ENGINEERING CHANGE (ECN) A36071

5178711DE

REV 2

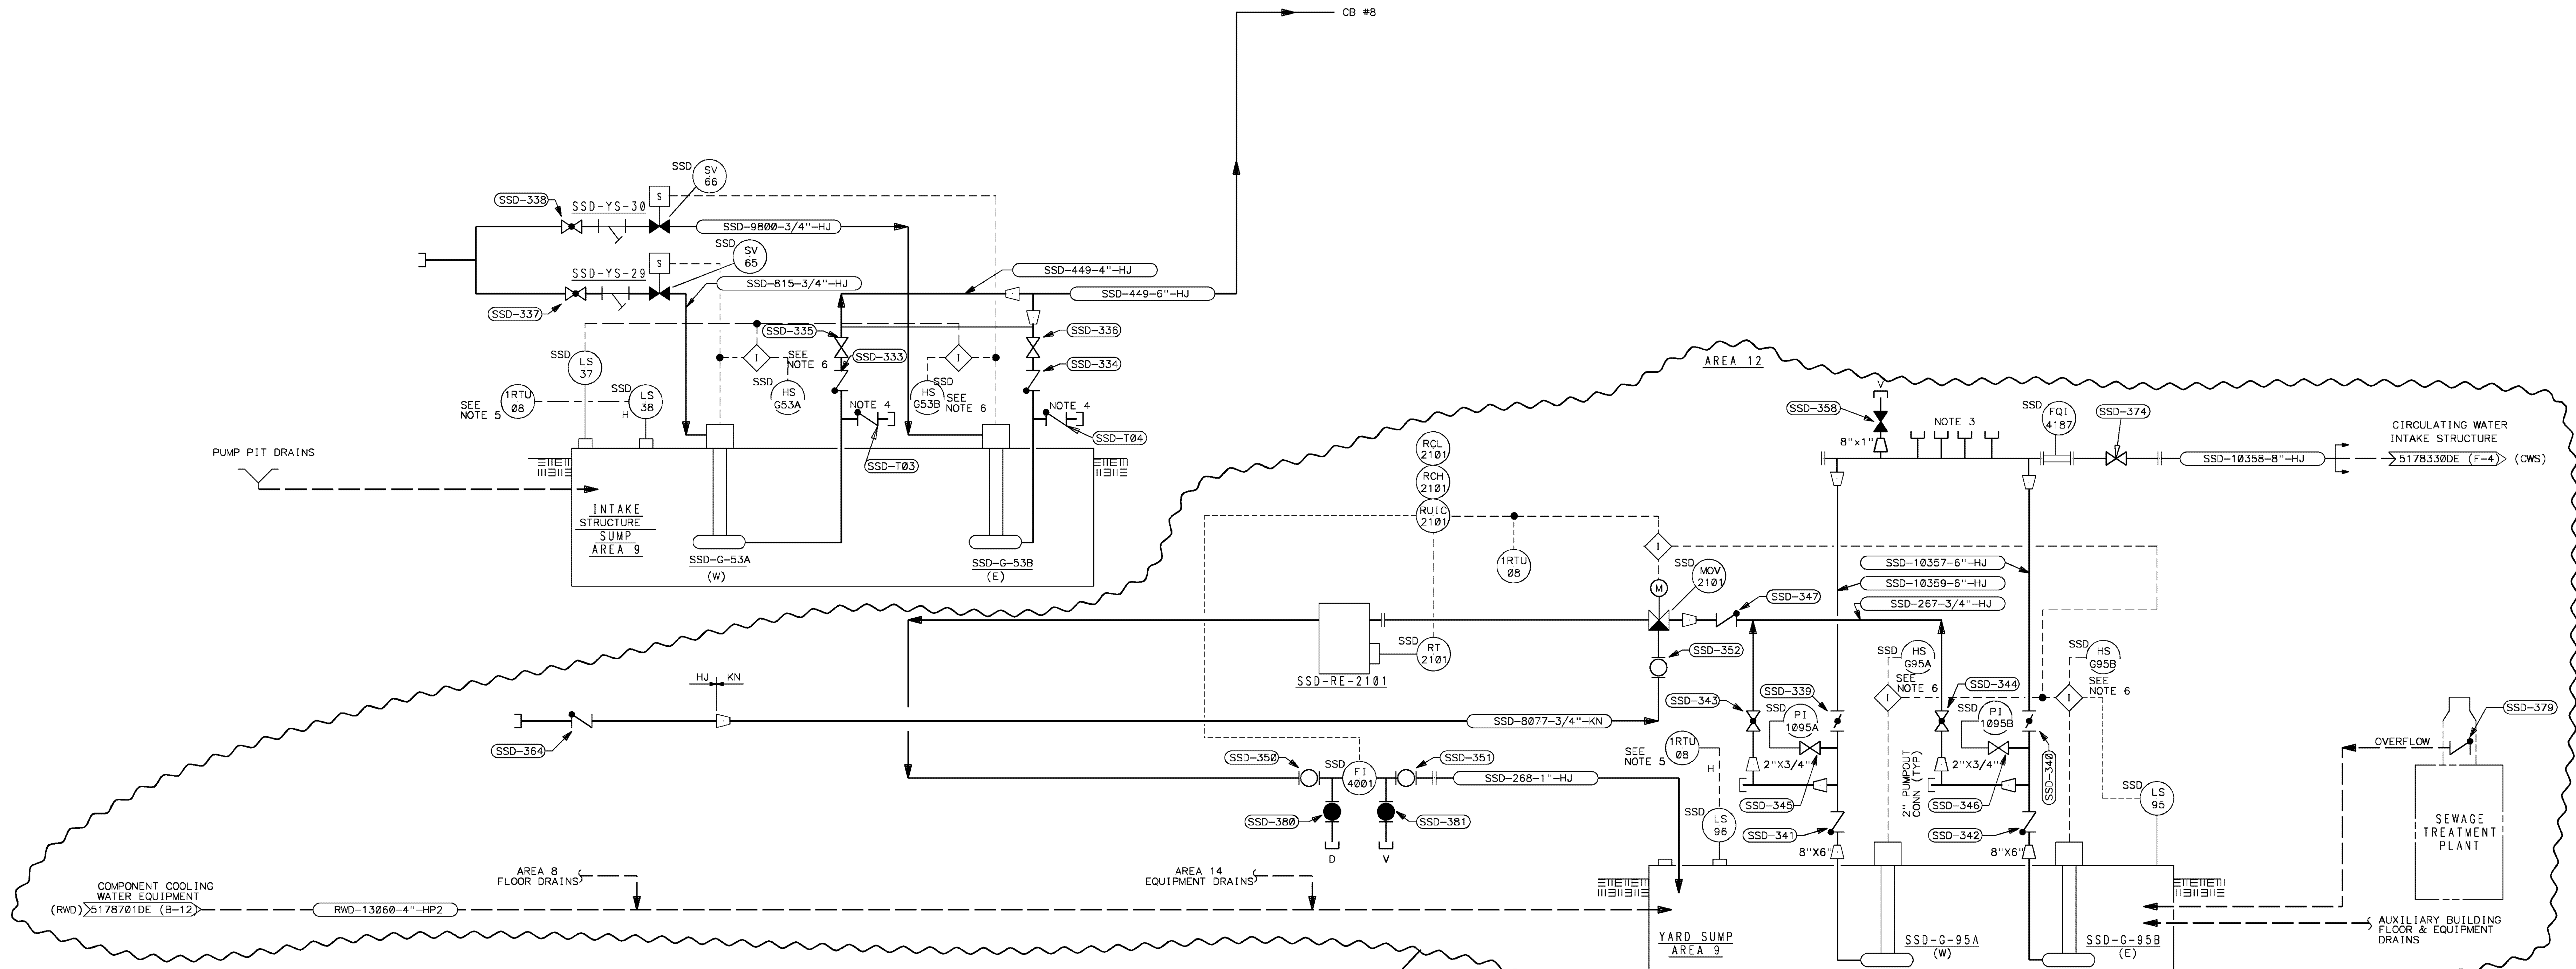
SSD-G-53A & G-53B  
INTAKE STRUCTURE  
SUMP PUMPS

SSD-RE-2101  
SAMPLER RADIATION MONITORING SKID

SSD-G-95A & G-95B  
YARD SUMP PUMPS

DELETE

DELETE

DELETE FROM DRAWING AFTER TURN OVER

DELETE
